TOWN AND COUNTRY ESTATES SUBDIVISION, RESUBDIVISION OF LOT 13, 14, AND 15 BLOCK N

APPLICATION NUMBER 5 DATE May 7, 2015

REQUEST Subdivision

DETAIL SITE PLAN

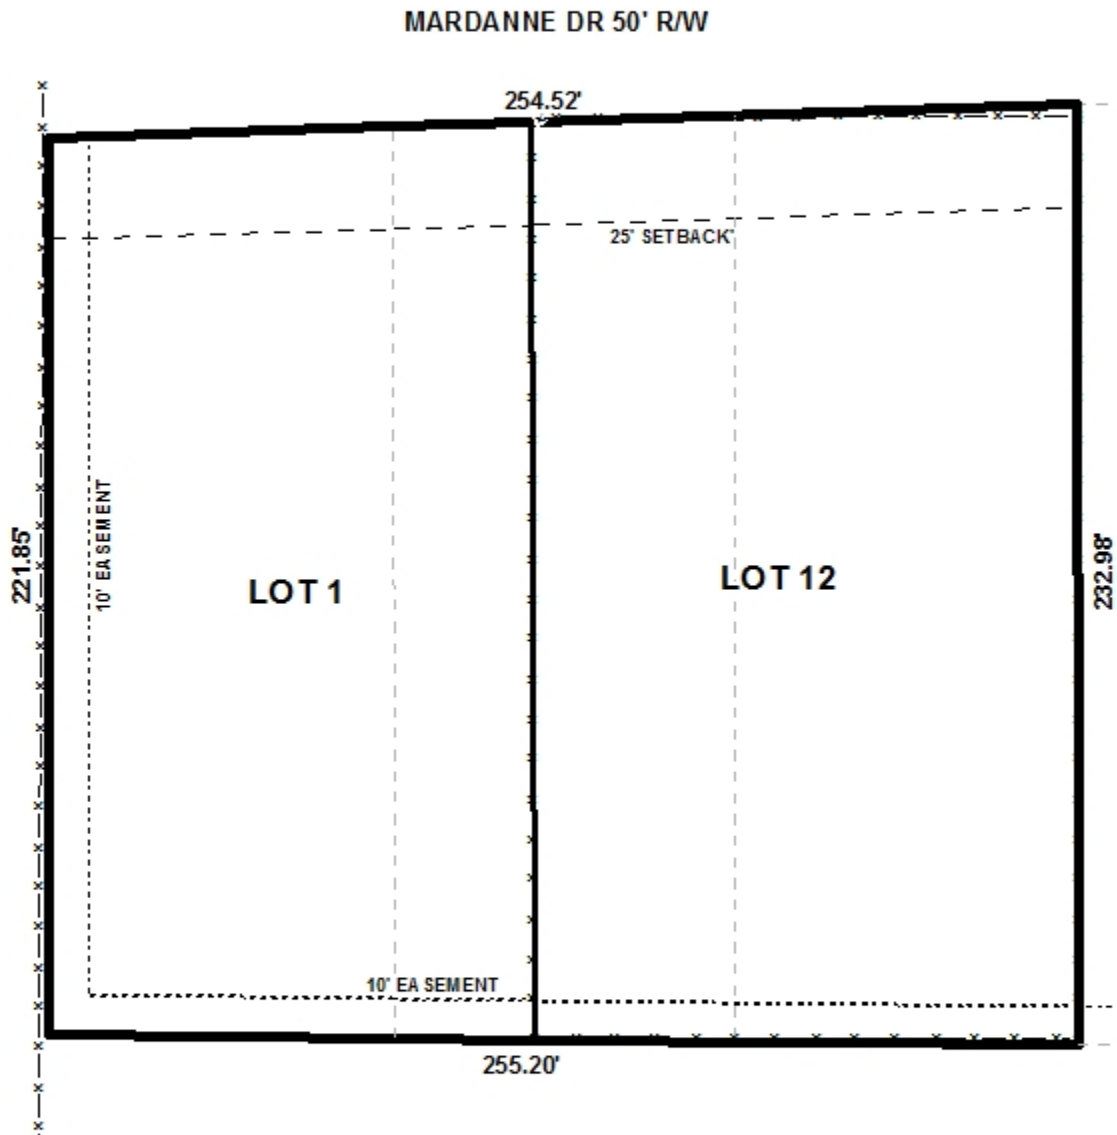
The proposed lots front Mardanne Drive, a paved minor street without curb and gutter. Mardanne Drive requires a 60' wide right-of-way width. The preliminary plat should depict the existing right-of-way width to be 60' with dedication sufficient to provide 30' from the centerline.

As a means of access management, a note should be placed on the Final Plat stating that the proposed Lot 1 should be limited to the existing curb-cut to Mardanne Drive, and that the proposed Lot 2 is limited to only 1 curb-cut to Mardanne Drive, with the size, design and location of the new curb-cut, and any changes to the existing curb-cut, are to be approved by Mobile County Engineering and conform to AASHTO standards.

In accordance with the Subdivision Regulations, both proposed lots appear to exceed the minimum lot size requirements; however, the lot size information should be revised to include both acres and square feet on the Final Plat, if approved.

The 25' minimum building setback line is also depicted on the preliminary plat, and should be retained on the Final Plat, if approved.

This site is located in the County, therefore any lots which are developed commercially and adjoin residentially developed property must provide a buffer, in compliance with Section V.A.8. of the Subdivision Regulations. A note so stating should be placed on the Final Plat, if approved.

- 1) Dedication sufficient to provide 30' from the centerline;
- 2) Placement of a note on the Final Plat stating that that the proposed Lot 1 is limited to the existing curb-cut to Mardanne Drive, and that the proposed Lot 2 is limited to only 1 curb-cut to Mardanne Drive, with the size, design and location of any new curb-cuts, and any changes to the existing curb-cut, to be approved by Mobile County Engineering and conform to AASHTO standards;

- 3) Revision of the lot size information to include both acres and square feet on the Final Plat;
- 4) Retention of the 25' minimum building setback line on the Final Plat;

- 5) Placement of a note on the Final Plat stating: *This site is located in the County, and therefore any lots which are developed commercially and adjoin residentially developed property must provide a buffer, in compliance with Section V.A.8. of the Subdivision Regulations.;*
